IWUIC

2024 GROUP A PROPOSED CHANGES TO THE I-CODES

April 7 – 16, 2024
Doubletree by Hilton
Universal Orlando - Orlando, FL

FIGURE H101.1(1) DETERMINATION OF REQUIREMENTS

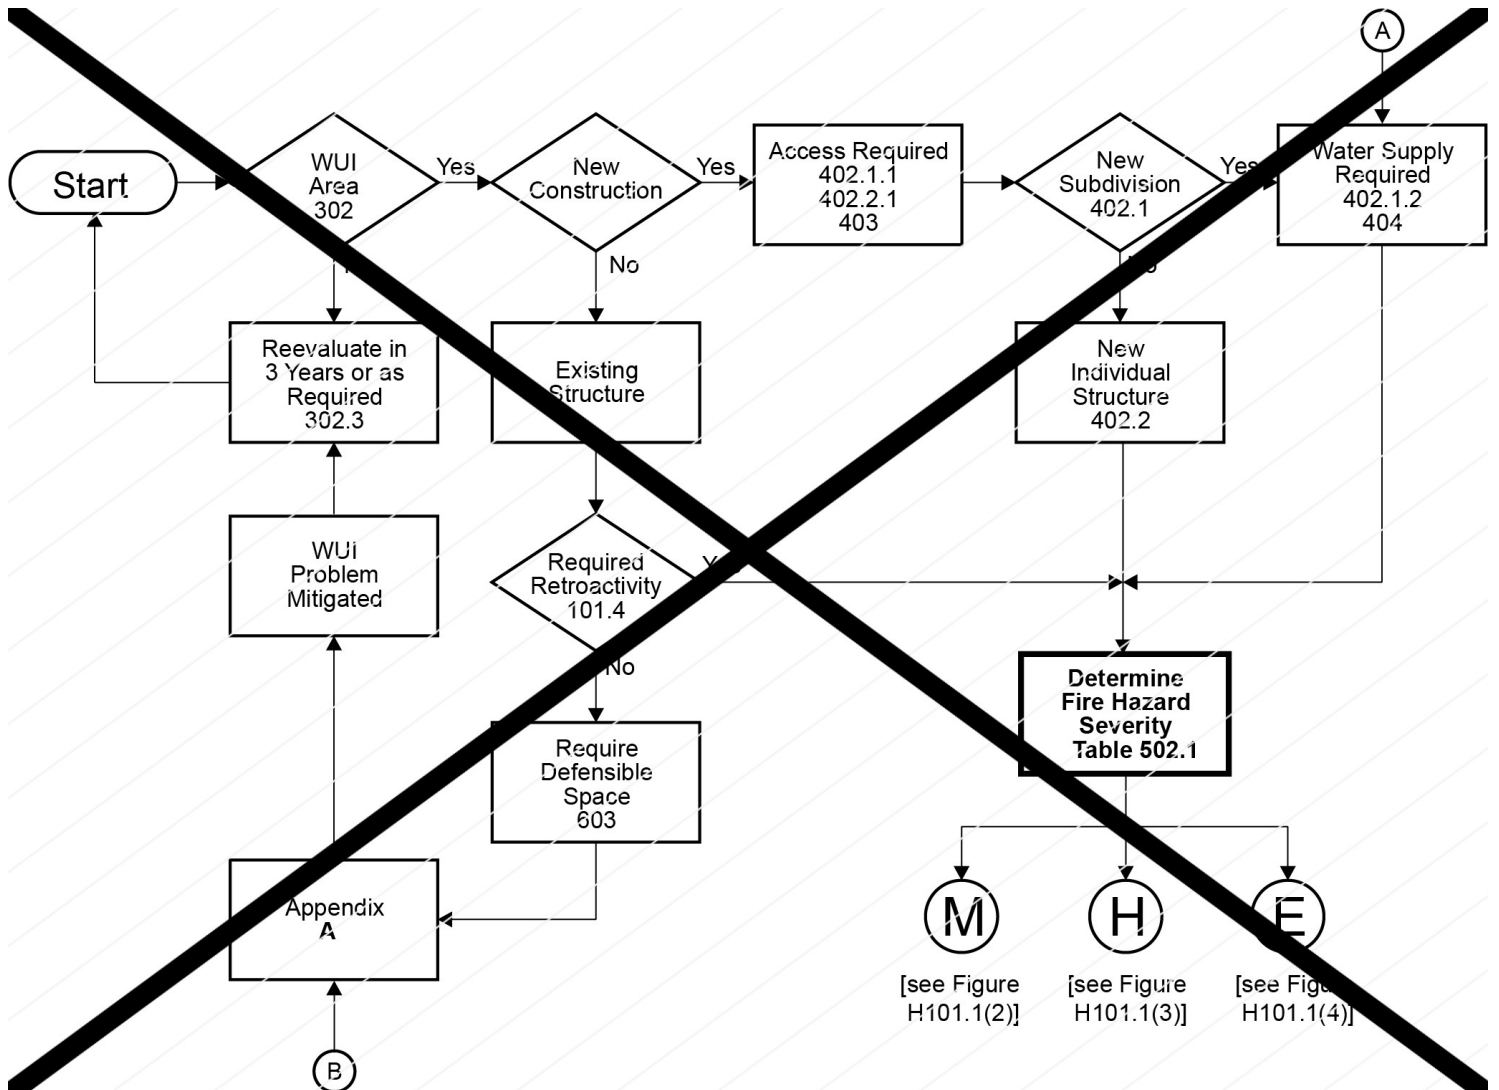
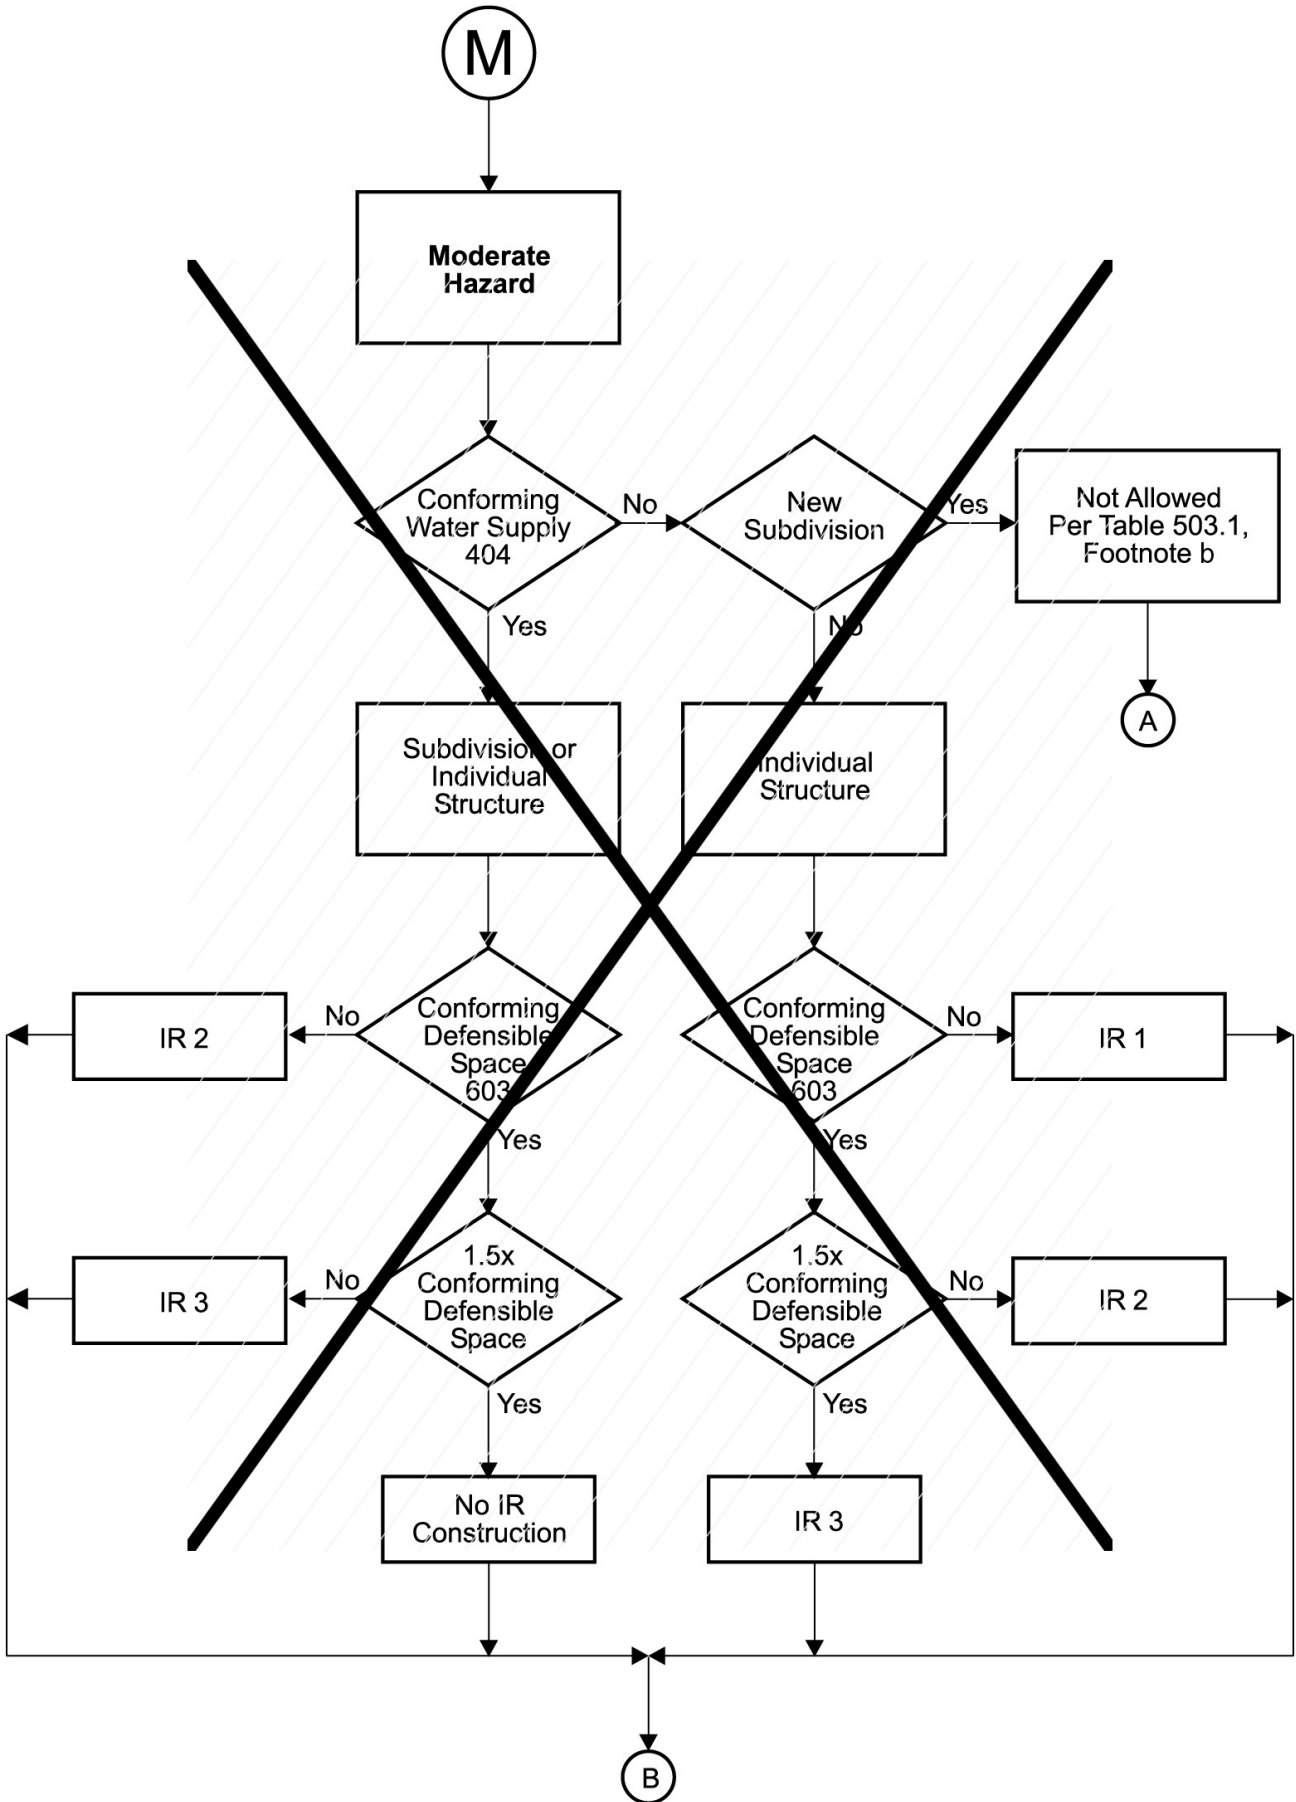
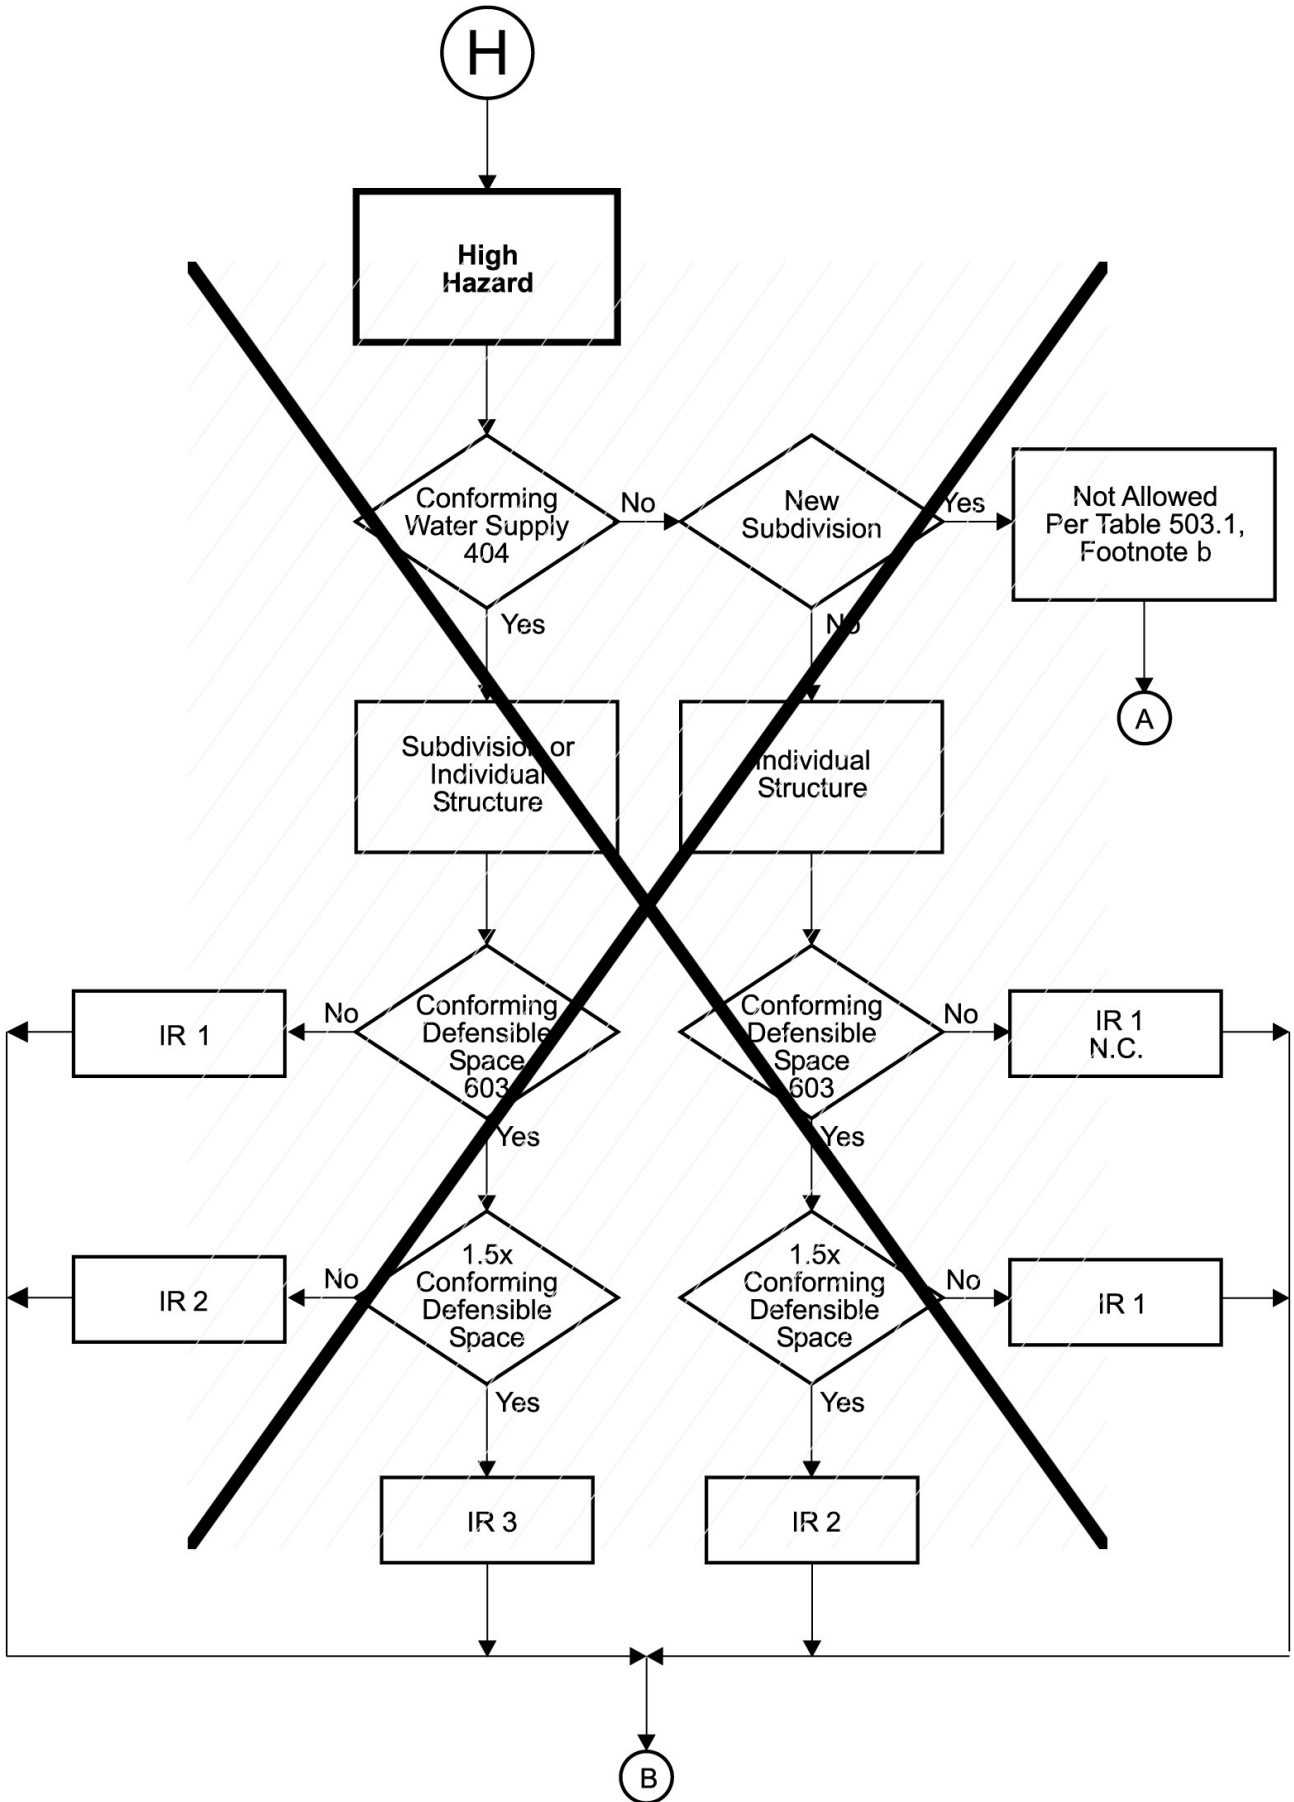
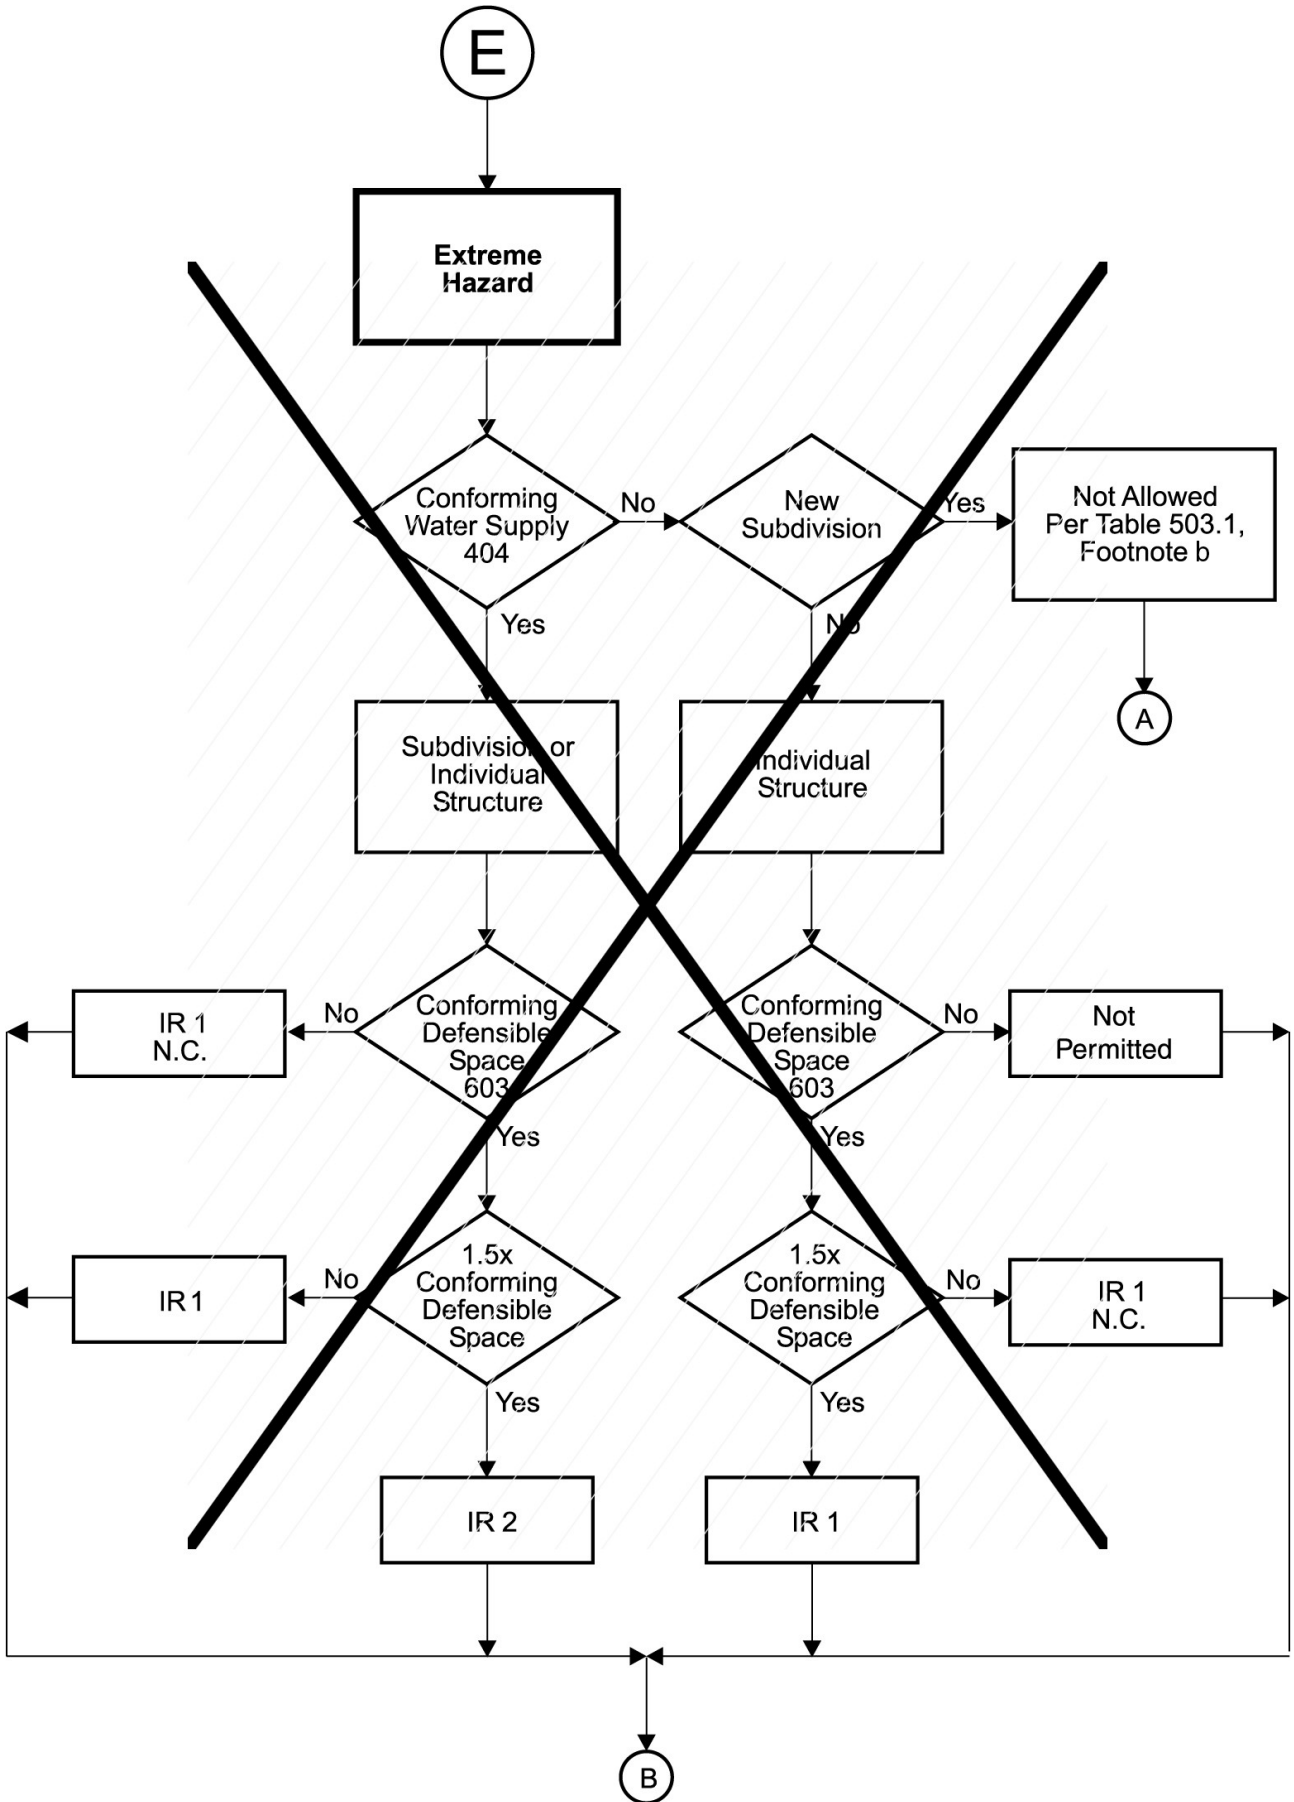
Reason: This proposal recommends deleting Appendix H without substitution. This appendix is an informational flowchart based on Table 503.1. It has been in the IWUIC since its first edition, in 2003, just like the Table it is based on.
